PROPOSED PLAN ;
CREATION OF
HARDSTANDING FOR
VEHICLE PARKING To ;

5 HILLSIDE CLOSE
HOYLANDSWAINE .

AMENDMENT To
APPLICATION /0949

OPTION 1

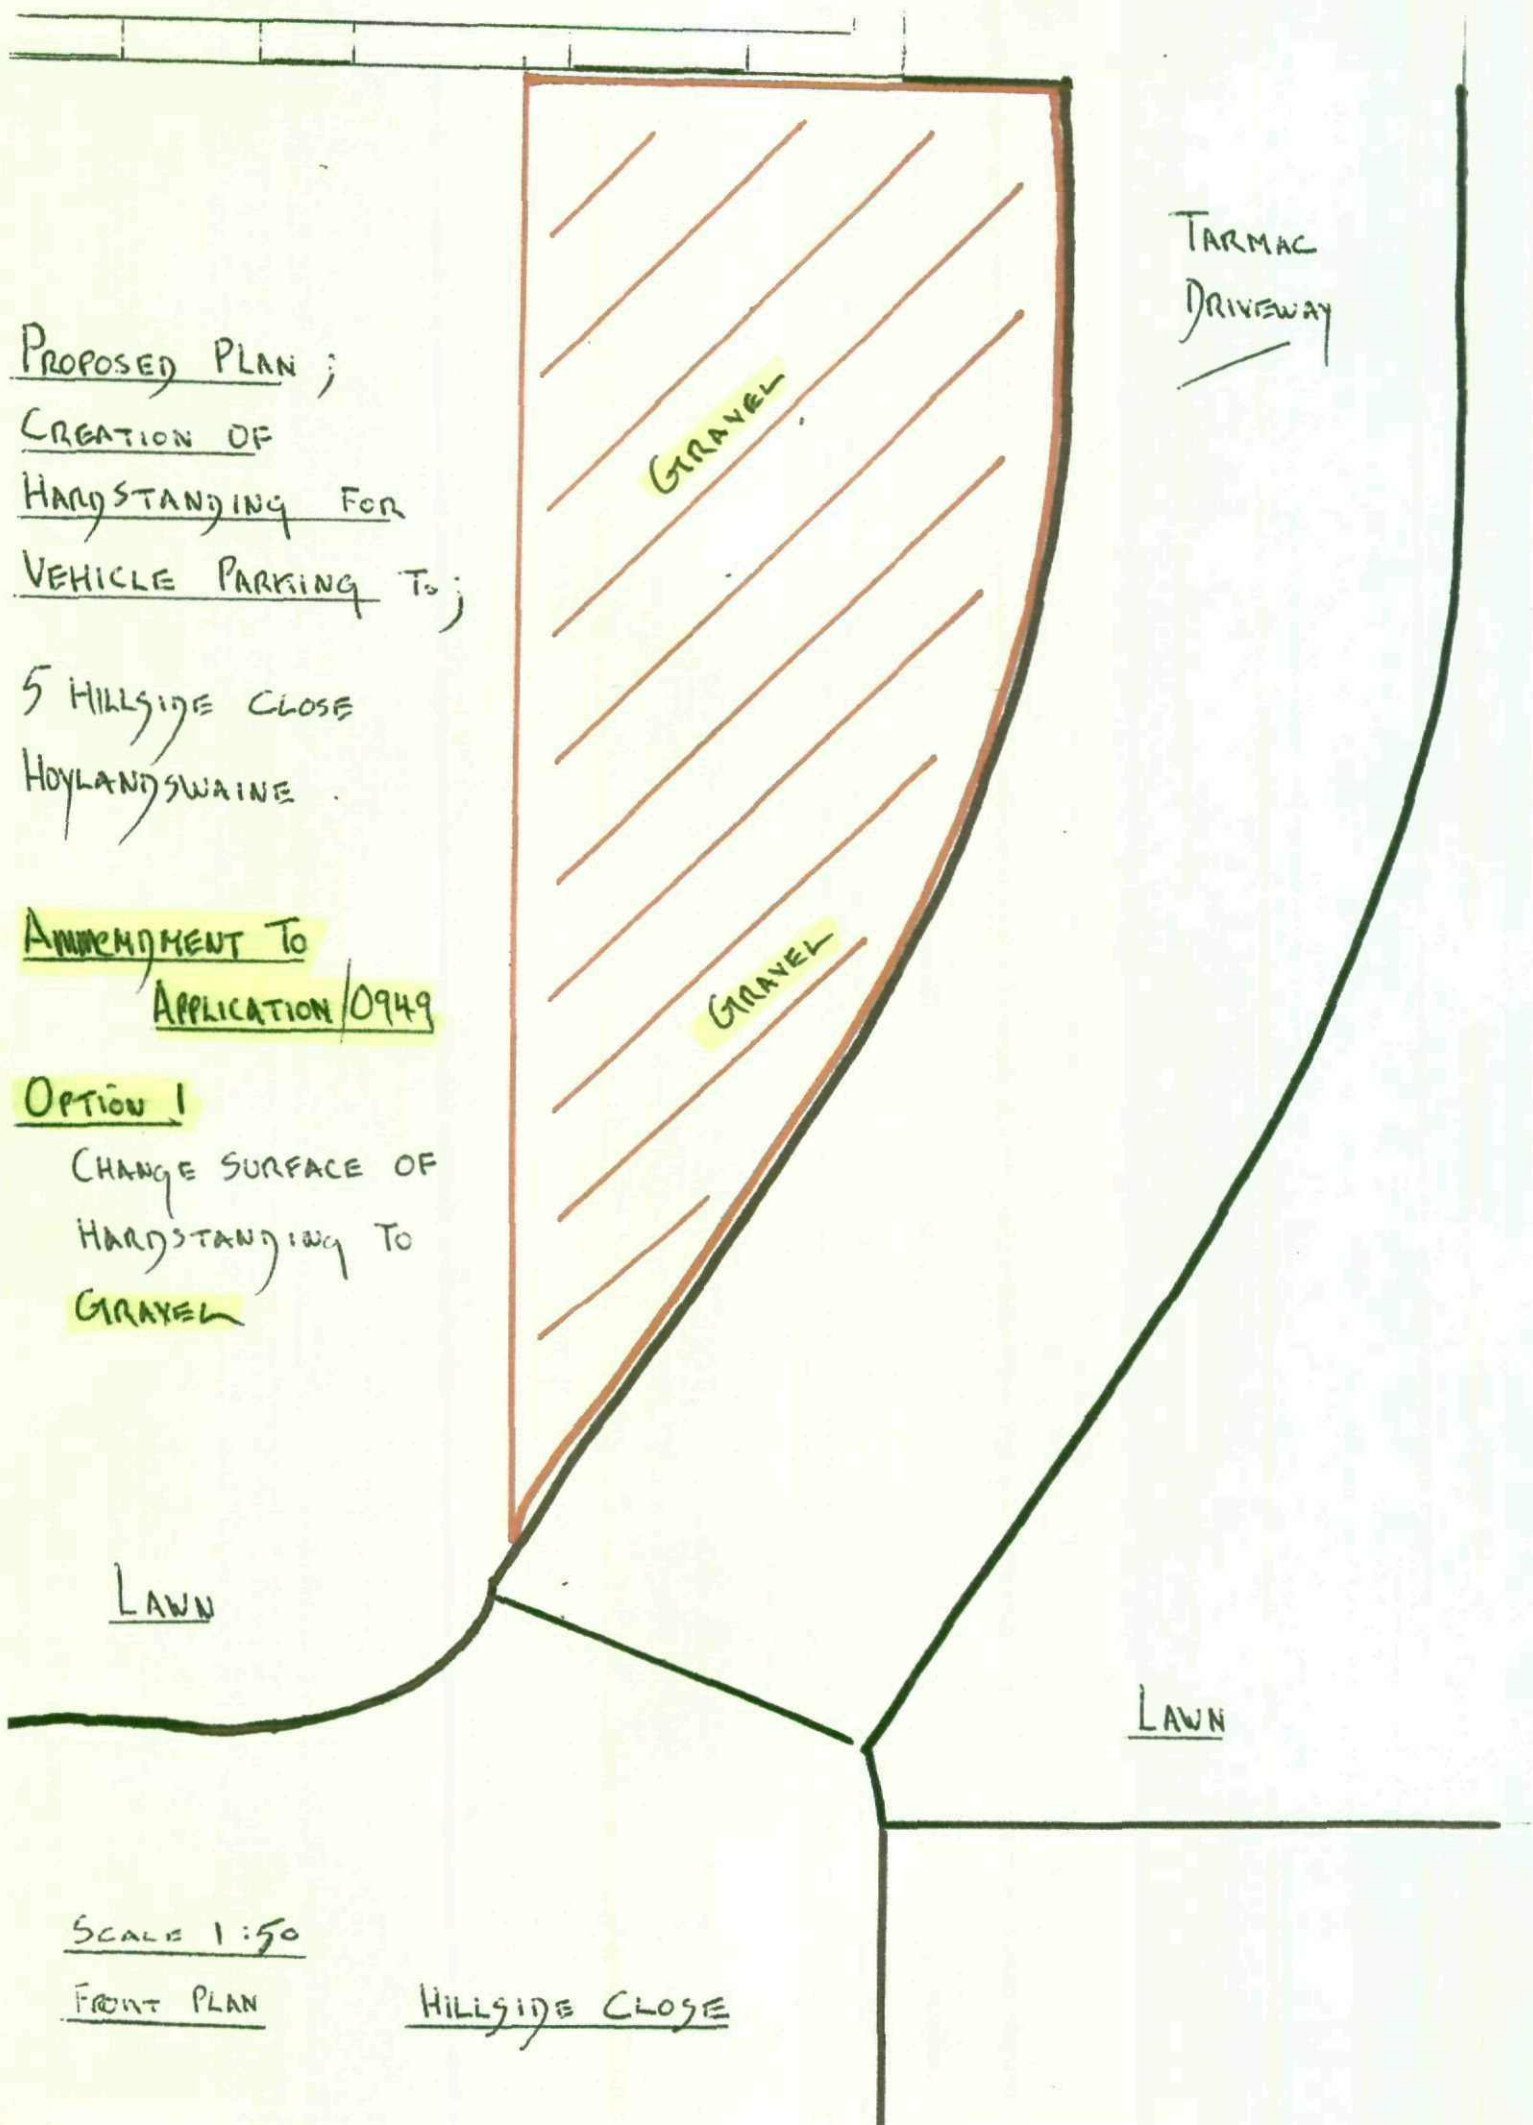
CHANGE SURFACE OF
HARDSTANDING TO
GRAVEL
